September 10, 2021

**SUBJECT: SIM Yard Charging Stations Project
CONTRACT NO. 071514**

ADDENDUM NUMBER # 02

1
D3.0

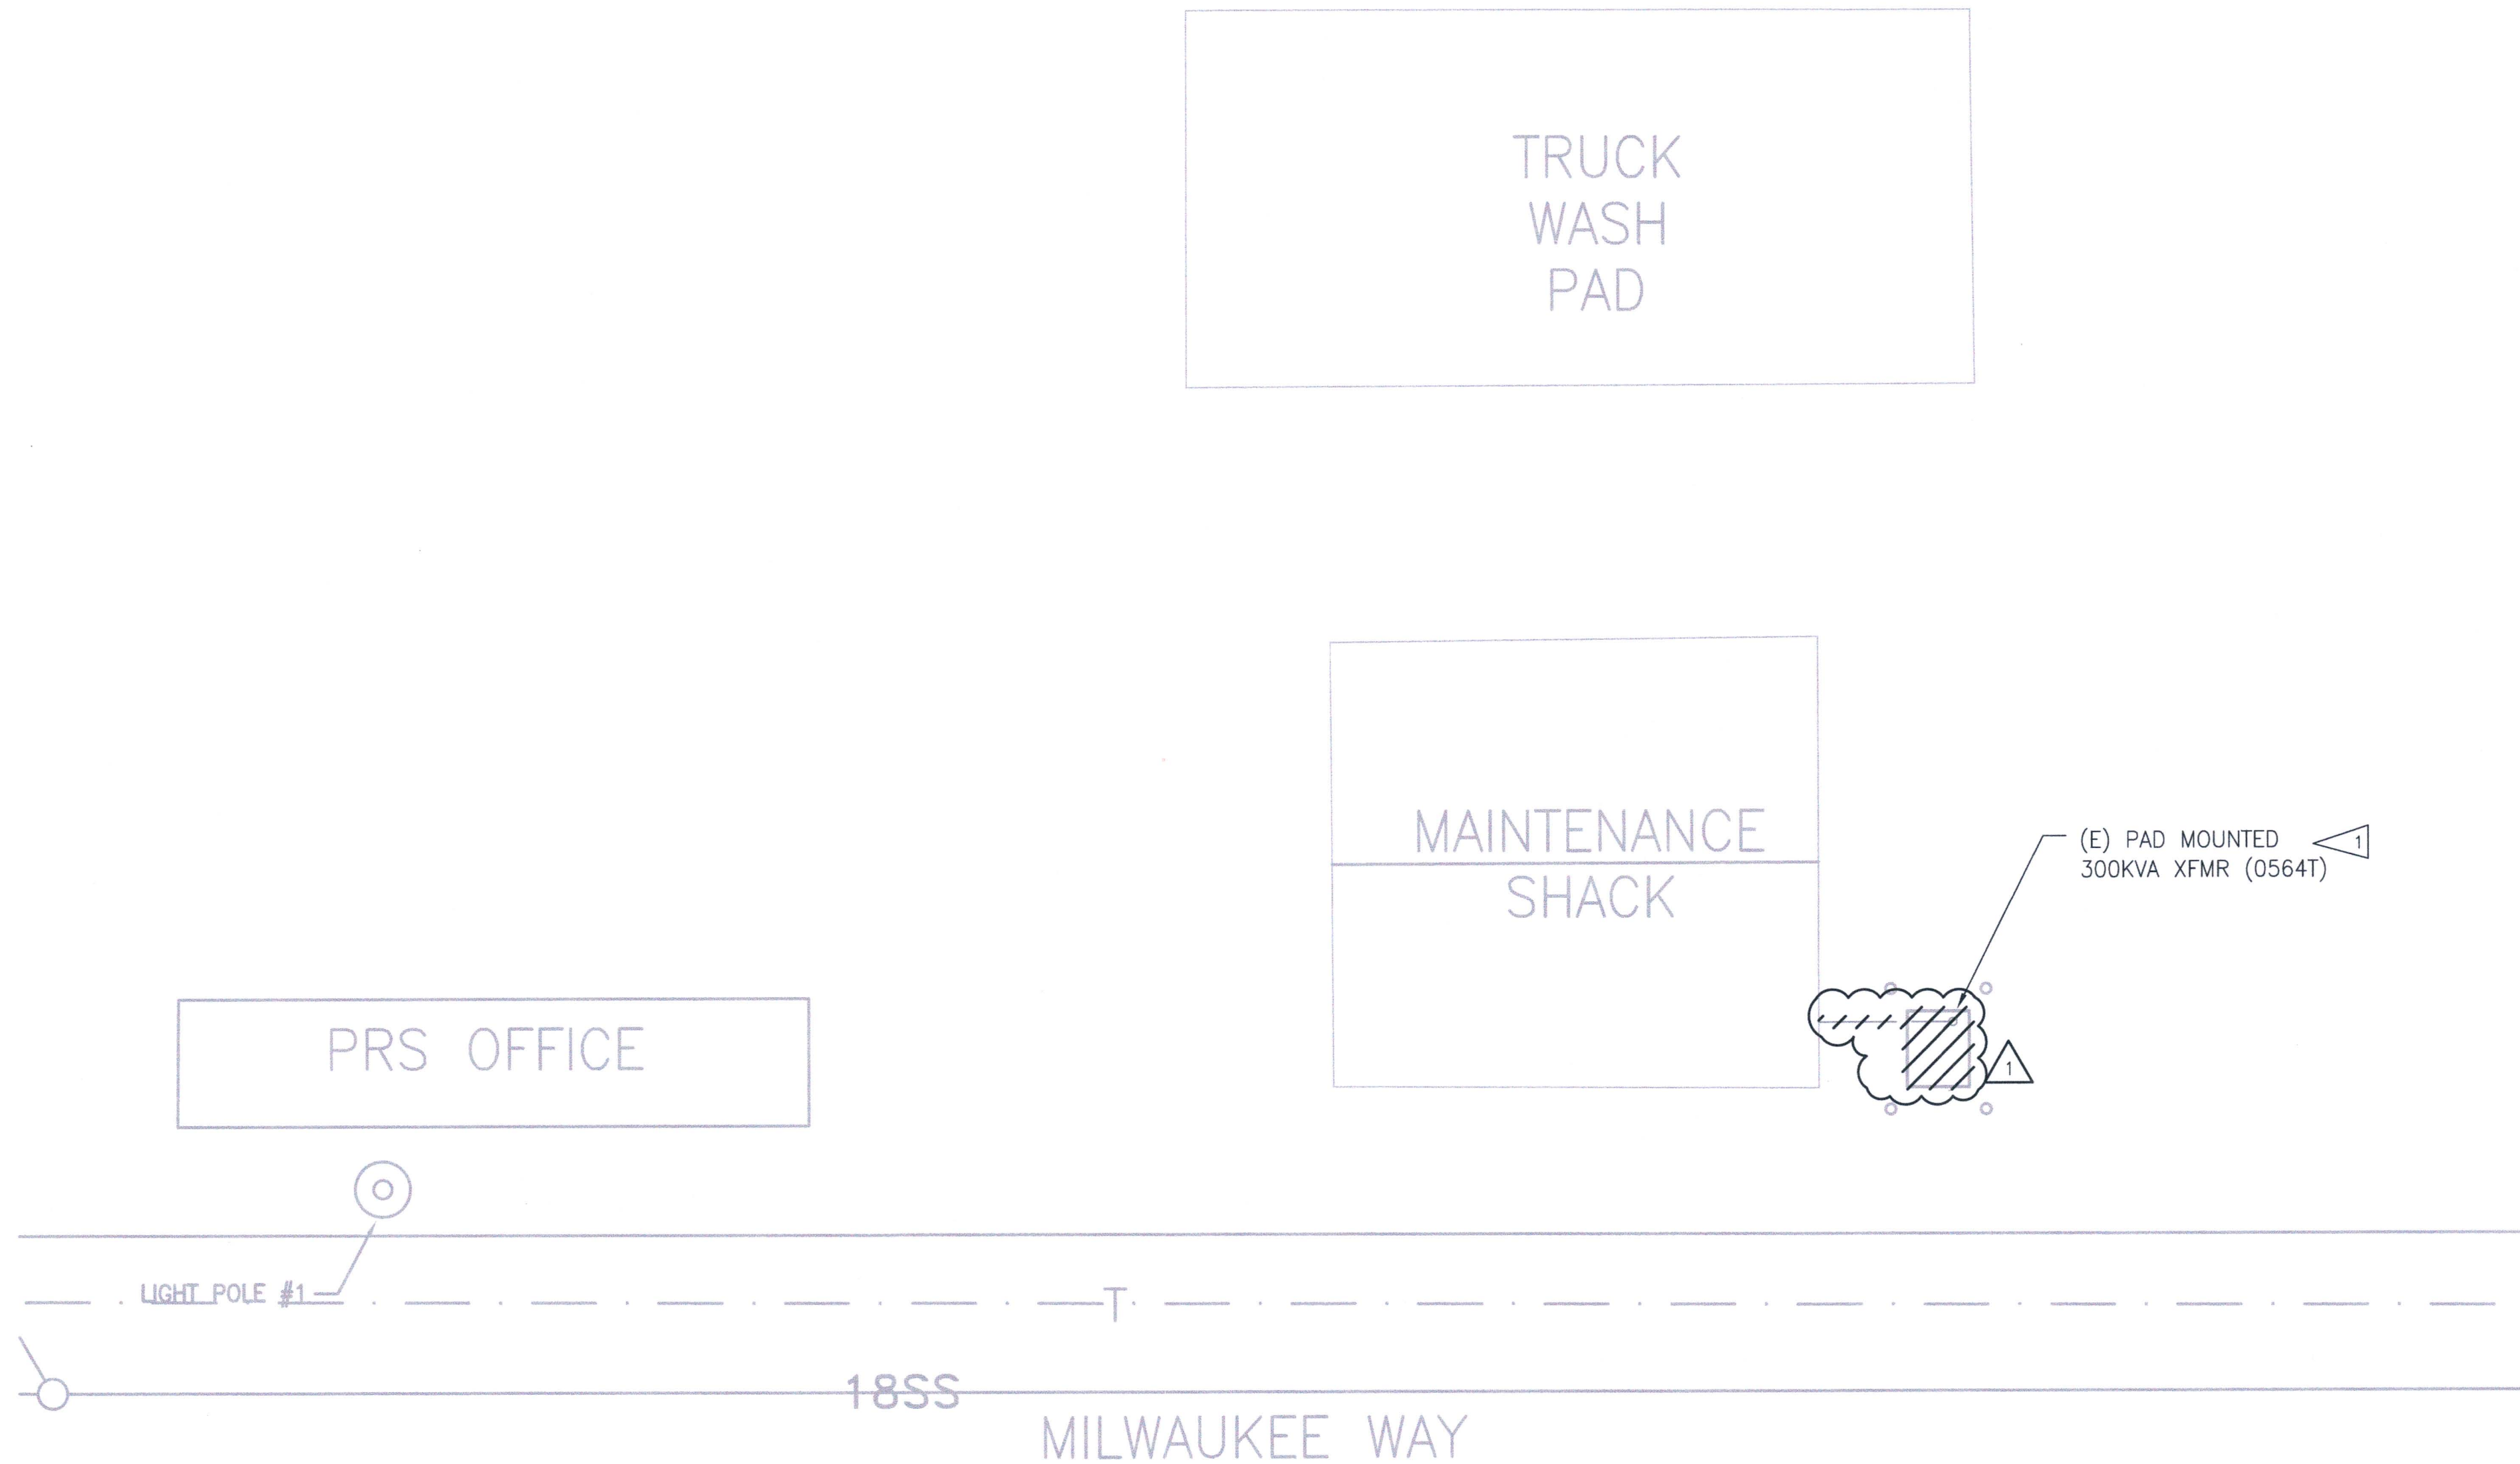
SHEET D3.0 – Electrical Site Plan – Demolition

- Revised Detail 1, Detail 2, and Electrical Note 1 to add and clarify electrical system demolition work.

1. TACOMA POWER SHALL DEENERGIZE AND REMOVE EXISTING 300 KVA TRANSFORMER AND 15KV CABLE. EXISTING PAD AND CONDUIT FROM EXISTING JUNCTION BOX SHALL REMAIN IN PLACE. COORDINATE WITH PORT OF TACOMA TO SCHEDULE OUTAGE.

2A
E2.0

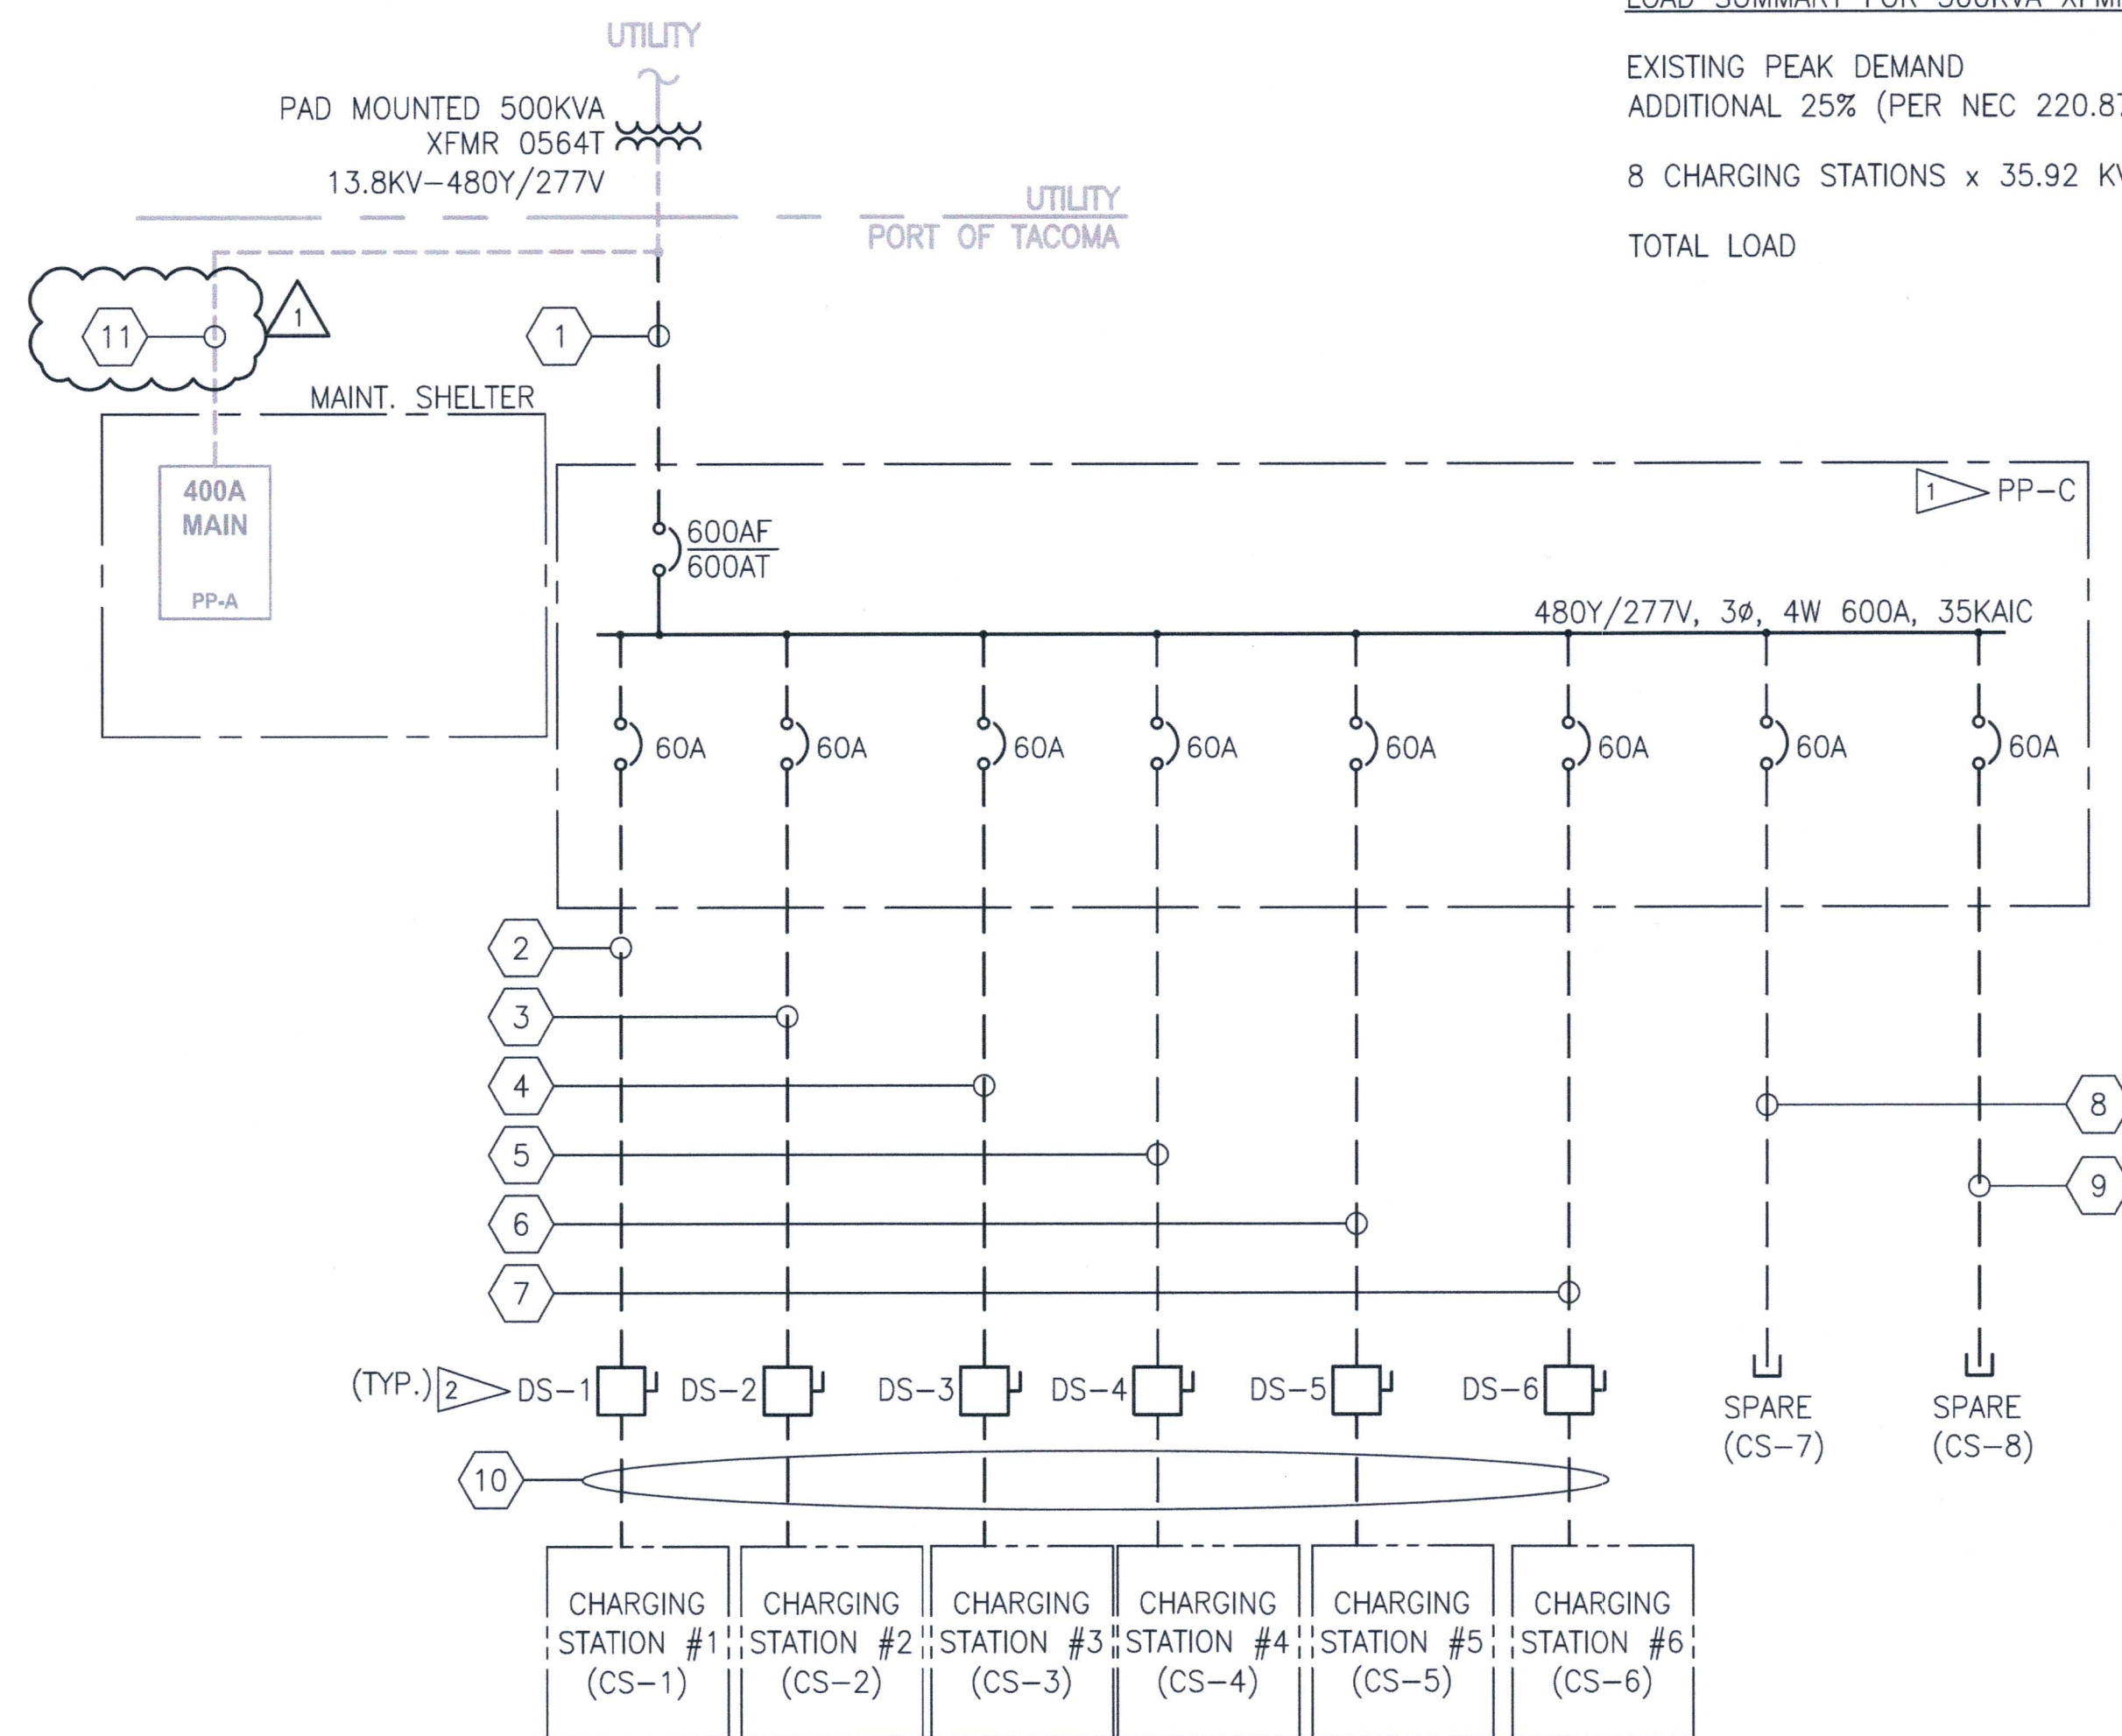
SHEET E2.0 – Electrical Site Plan

- Revised Detail 1 and Detail 2 to depict additional conduit and cabling work required to accommodate upgraded Tacoma Power transformer.
- Revised Electrical Note 5 to clarify cabling requirements.
- Added Electrical Notes 6 & 7 with reference to relevant civil sheet and requirement to provide backup generator.

- 5> PROVIDE 3"C, 3#500, #3GND, THROUGH EXISTING JUNCTION BOX LOCATED ON EAST WALL OF MAINTENANCE SHACK FROM VAULT-MOUNTED TRANSFORMER TO EXISTING PANEL (PP-A).

- 6> REFERENCE CIVIL SHEET C2.0 FOR TRANSFORMER VAULT DIMENSIONS, LOCATION AND INSTALLATION DETAILS.
- 7> PROVIDE BACKUP GENERATOR DURING OUTAGE OF EXISTING PANEL (PP-A).
